FOREST LAKES FILING NO. 7

CONSTRUCTION PLANS

PCD FILE # SF-21-49

FOREST LAKES FILING NO. 7
 CONSTRUCTION PLANS
 PUBLIC STORM SEWER PLAN
 'MAIN E' / 'MAIN E LATERAL 1'
 DESIGNED BY: MAL SCALE: (H) 1" = 50' DATE: 06/01/21
 DRAWN BY: MES SHEET 19 OF 31
 CHECKED BY: (V) 1" = 5' JOB NO. 1175.70

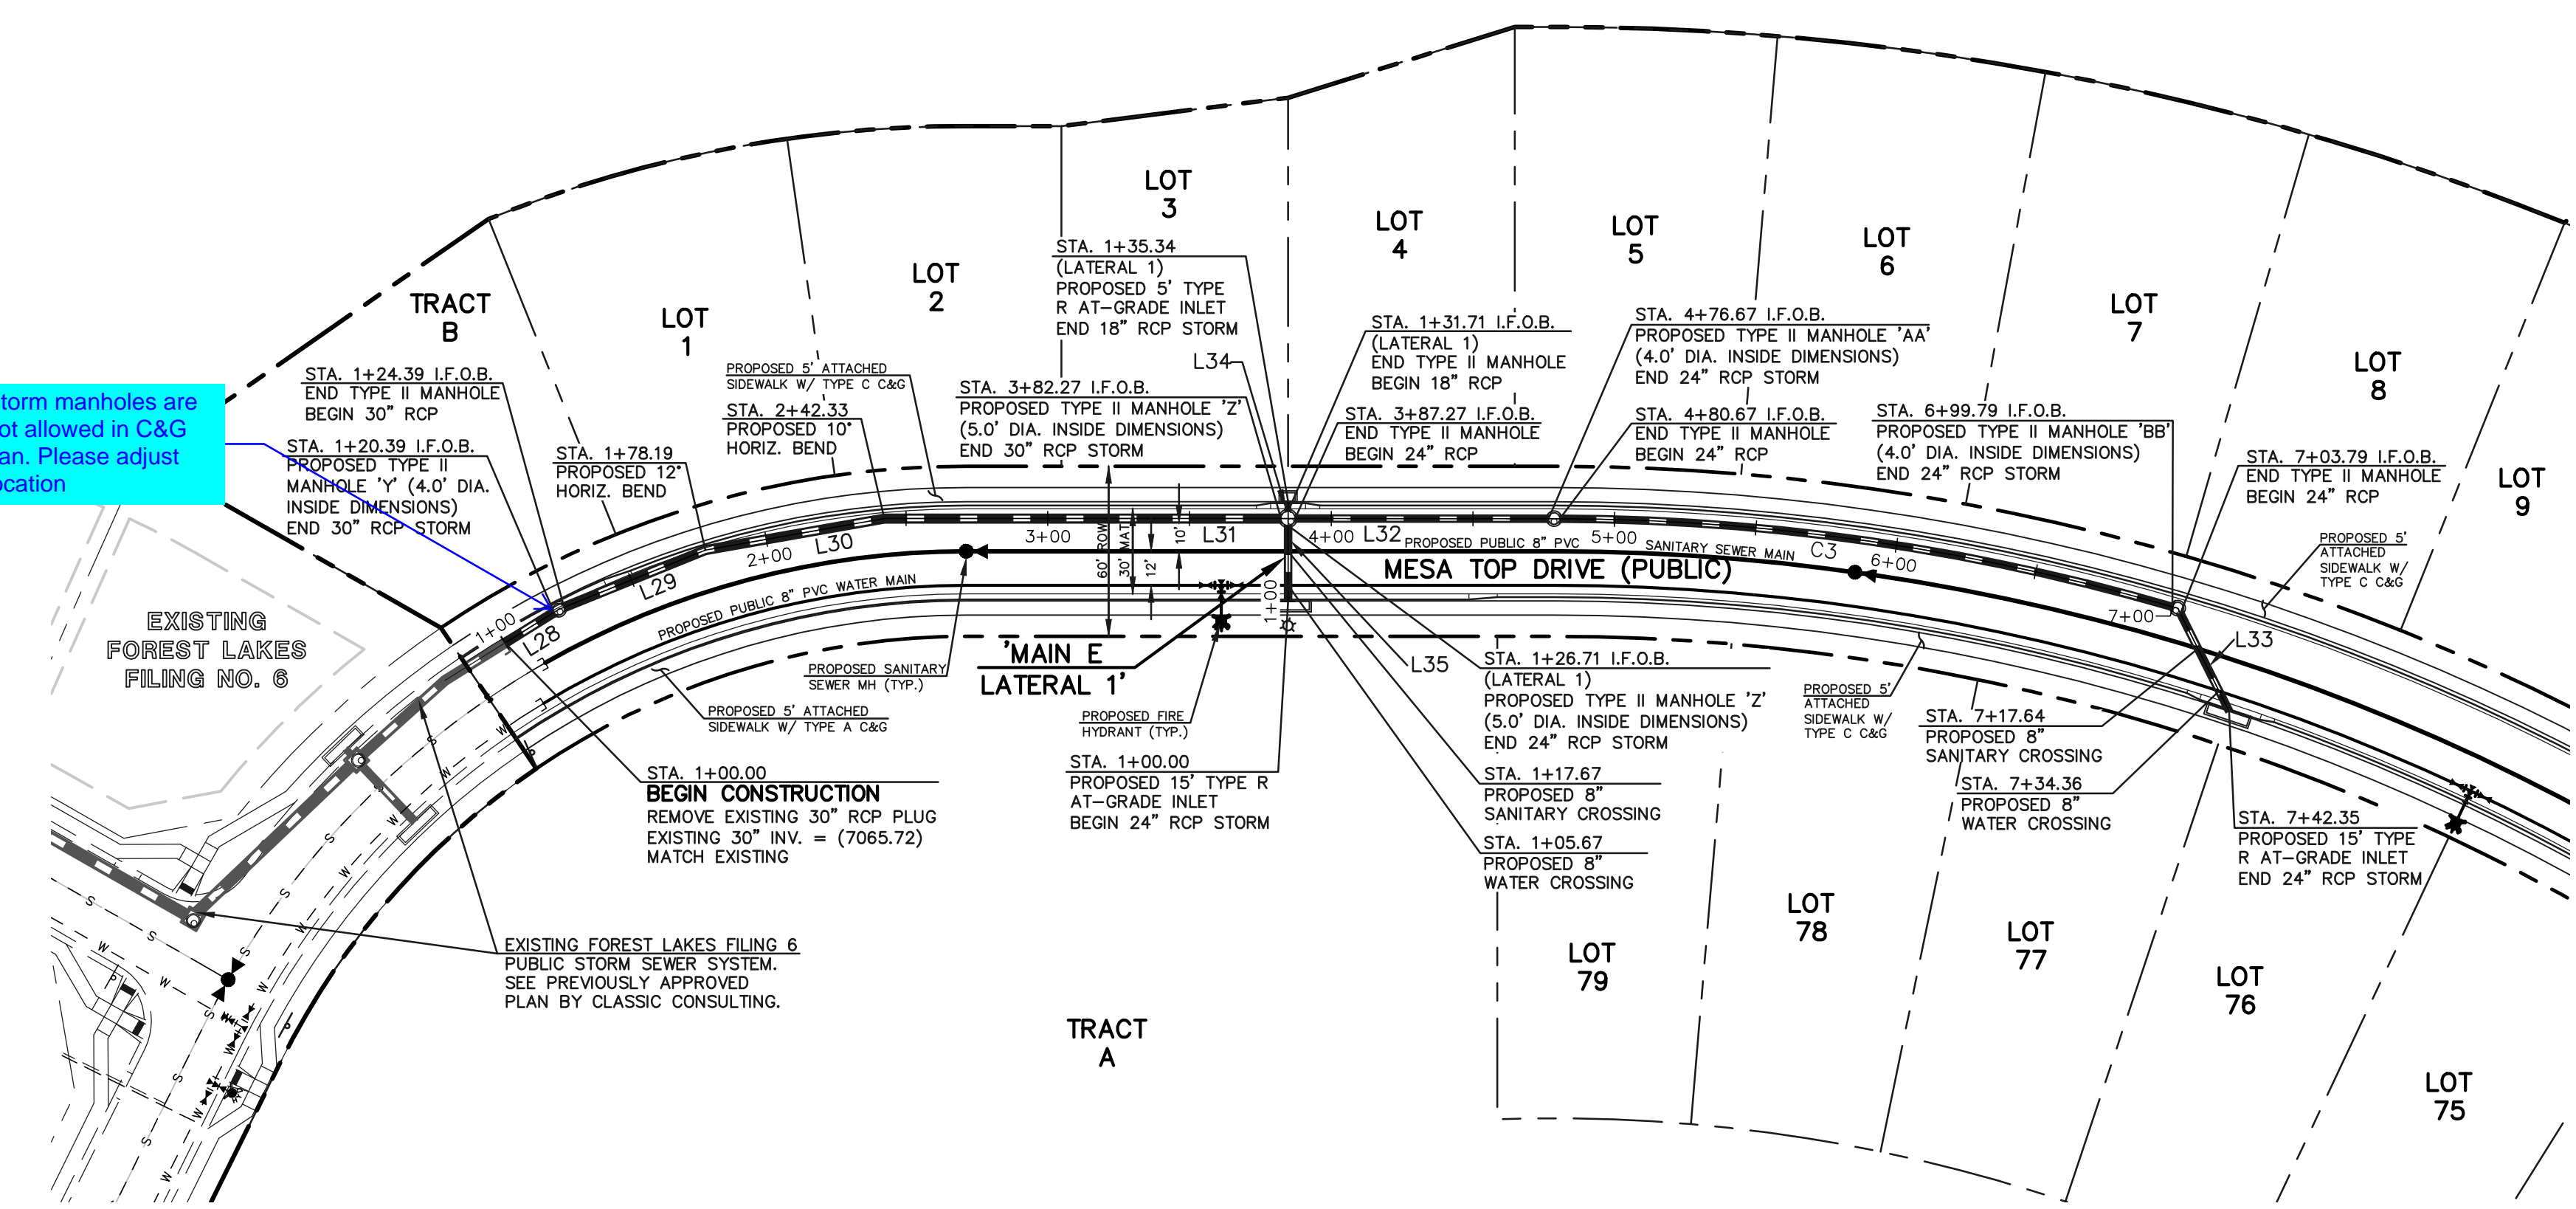
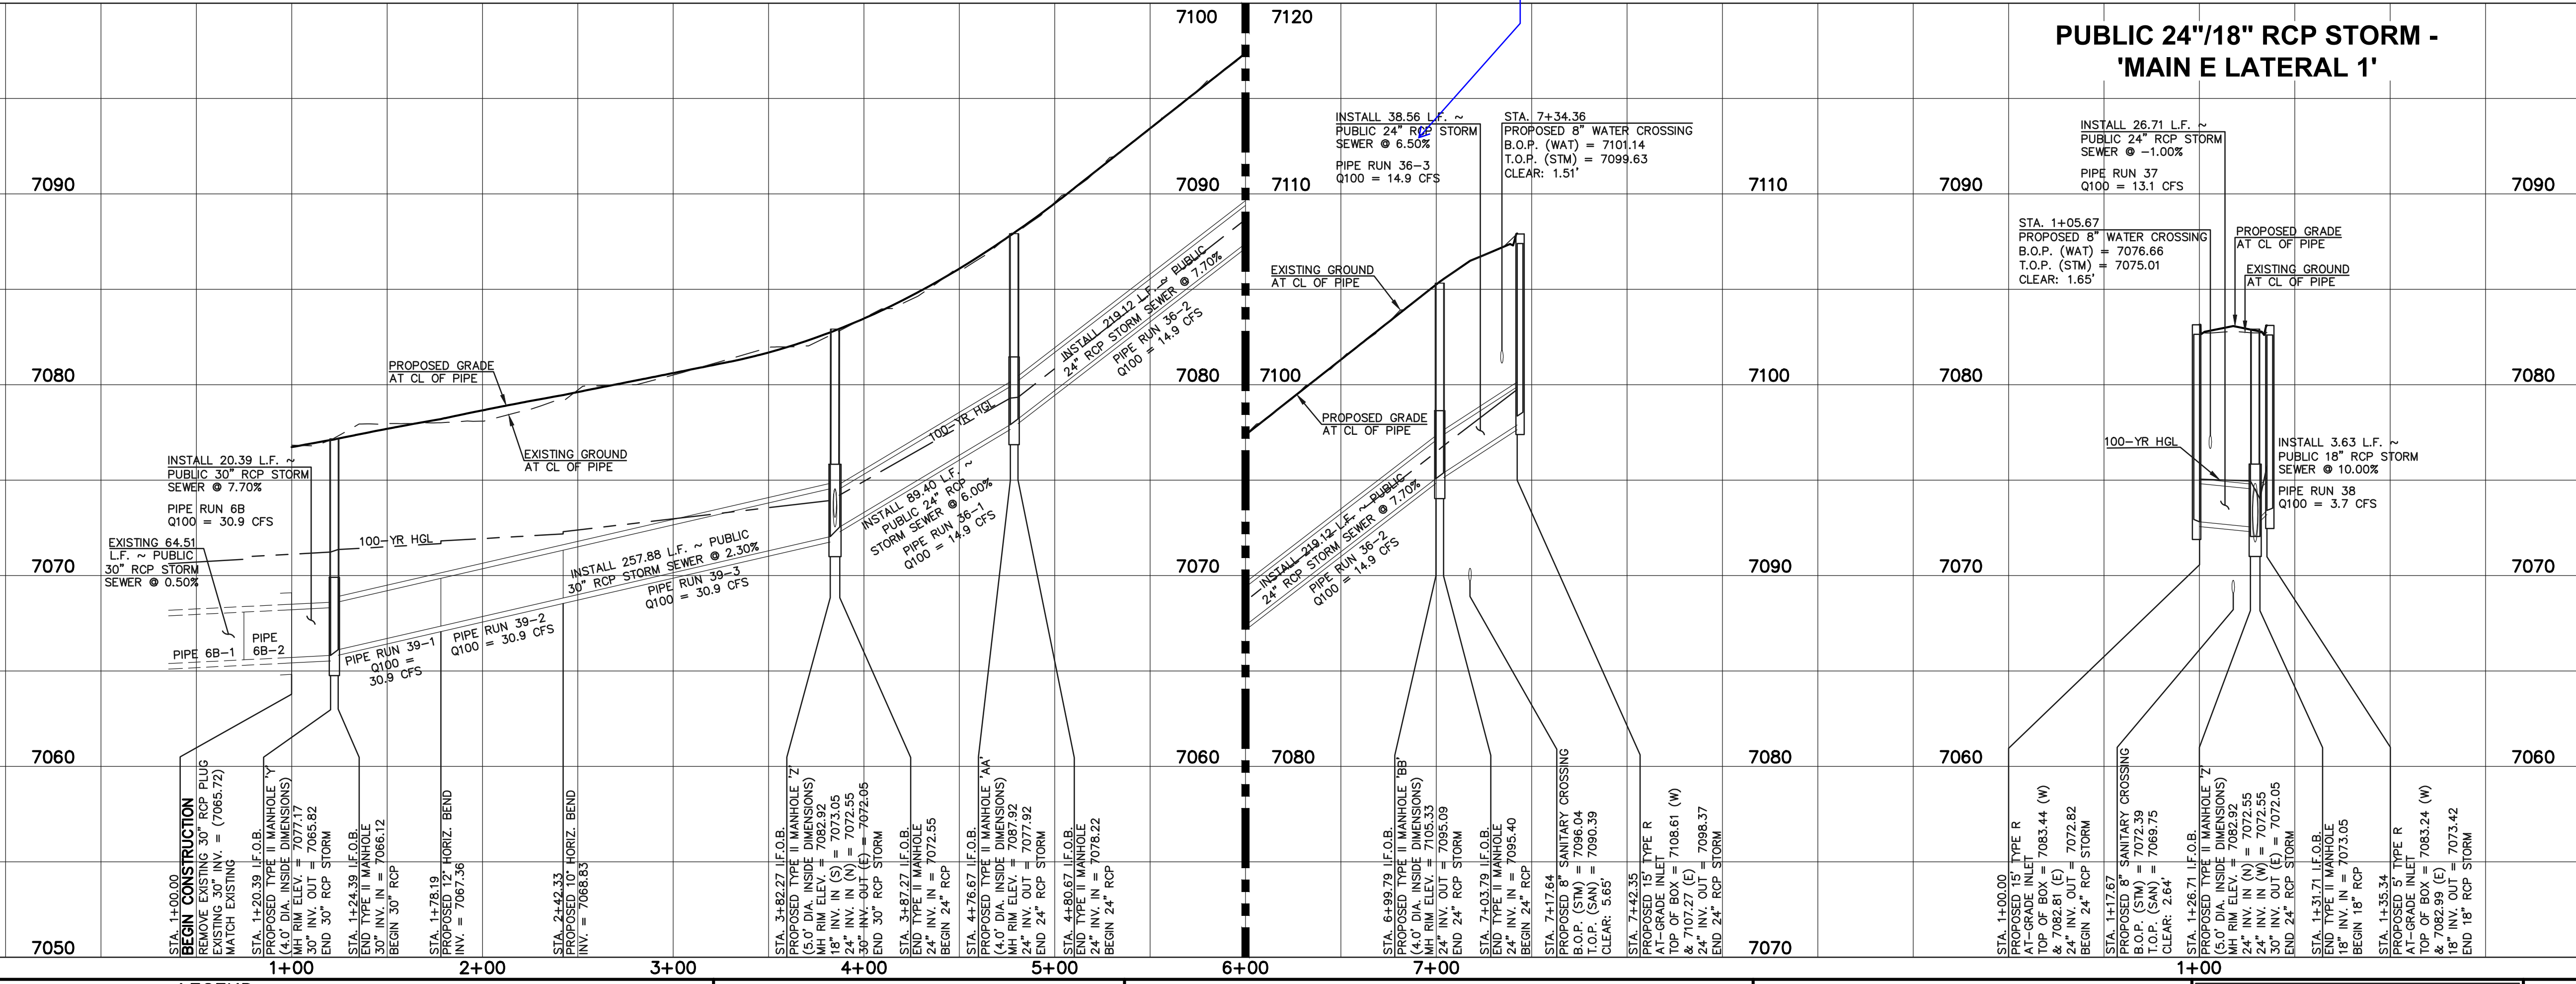
Storm manholes are not allowed in C&G pan. Please adjust location

HGL sheet shows 7.7%. Coordinate and update between CD's and HGL sheet accordingly.

CDOT MANHOLES
STD. PLAN NO: M-604-20

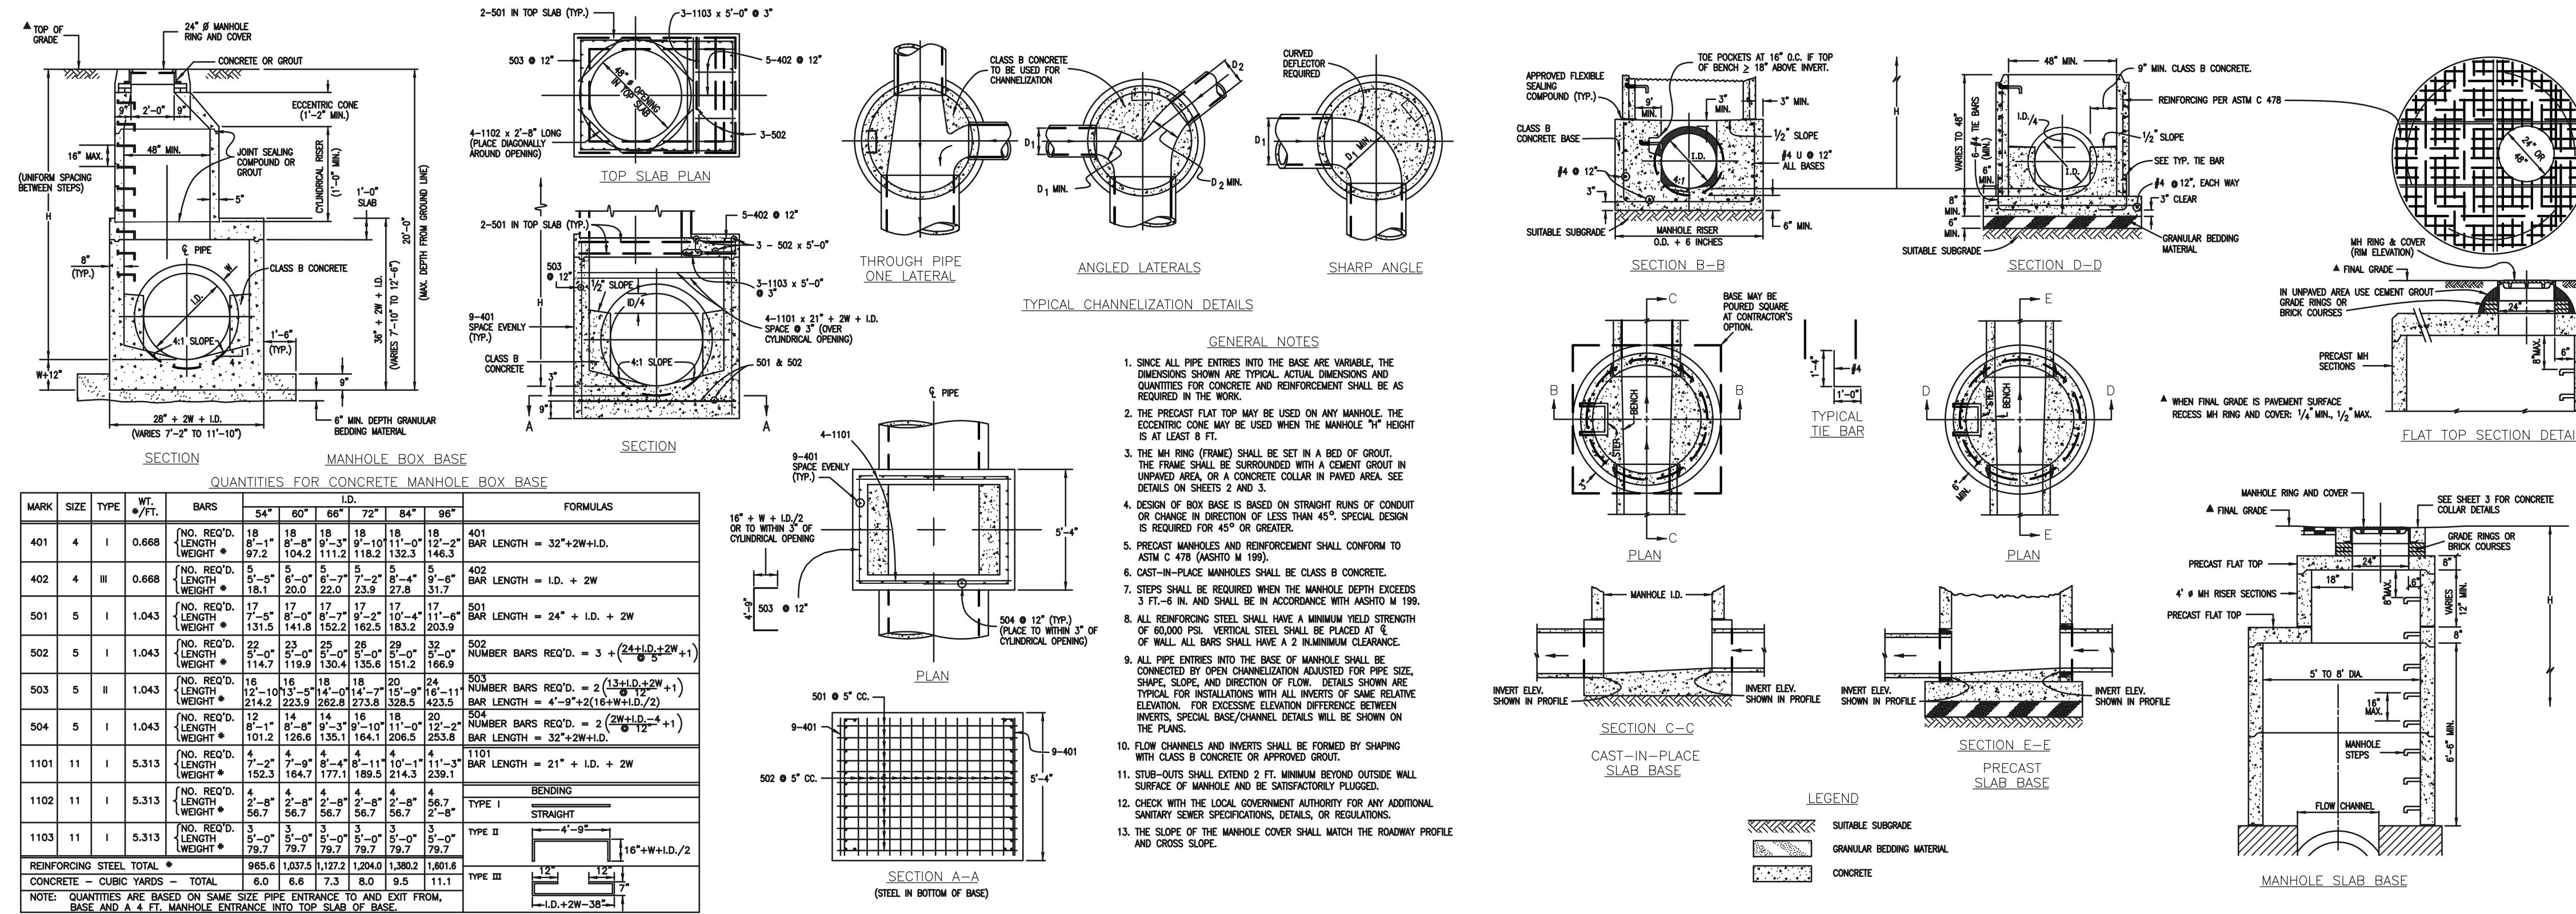
Include detail for Type II manhole
